**240-246 Normanby Road, South Melbourne (Site 04) - 6/2015/MIN/A - C195port  
City of Port Phillip Site – Internal referral responses**

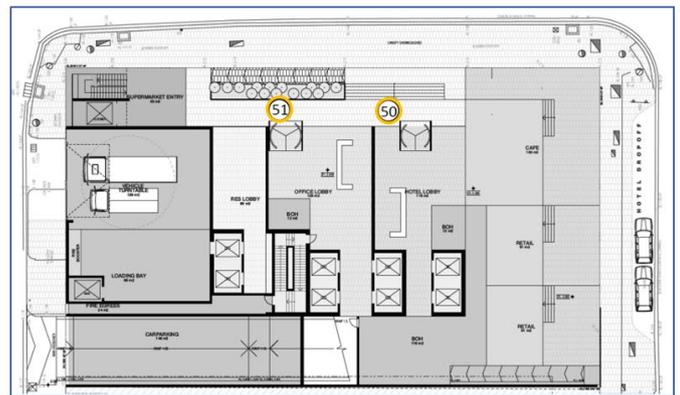
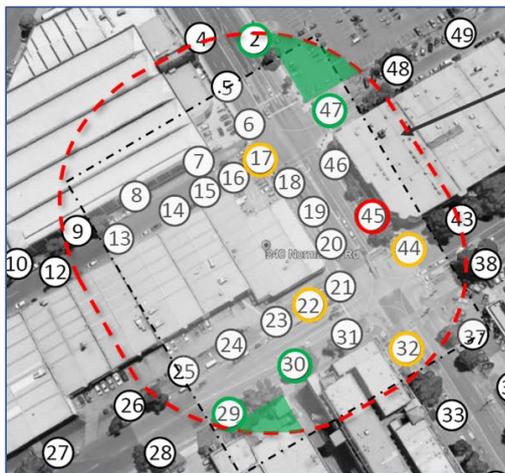
This outcome is particularly relevant for the subject site, which is located within the Montague Core Area where a *“high quality, high amenity public realm is to be delivered”* (Clause 21.06-8). Normanby Road is to be a *“pedestrian friendly boulevard”*. Based on the requirements of Clause 2.11 of DDO30, an assessment distance of approximately 54m is required from the site boundaries (based on current building height). As illustrated in the diagram below, this area encompasses the following public areas that will perform important roles in the amenity and livability of the area:

- Footpaths on both sides of Normanby Road and Montague Street;
- New park at the northeast corner of Montague and Munro and Salmon Streets;
- New park on the opposite side of Normanby Road; and
- Proposed through-block laneways.

On this basis, adoption of walking comfort criteria for most publicly accessible areas is not supported, as this undermines the purpose of these areas.

An amended wind assessment is required that demonstrates compliance with the above planning requirements. Managing wind impacts on the public realm is closely associated with built form. Required wind treatments will need to be incorporated into the design of the development. On this basis, the wind assessment needs to be prepared, and the above matters addressed, prior to a decision being made. The amended wind assessment needs to address the following matters:
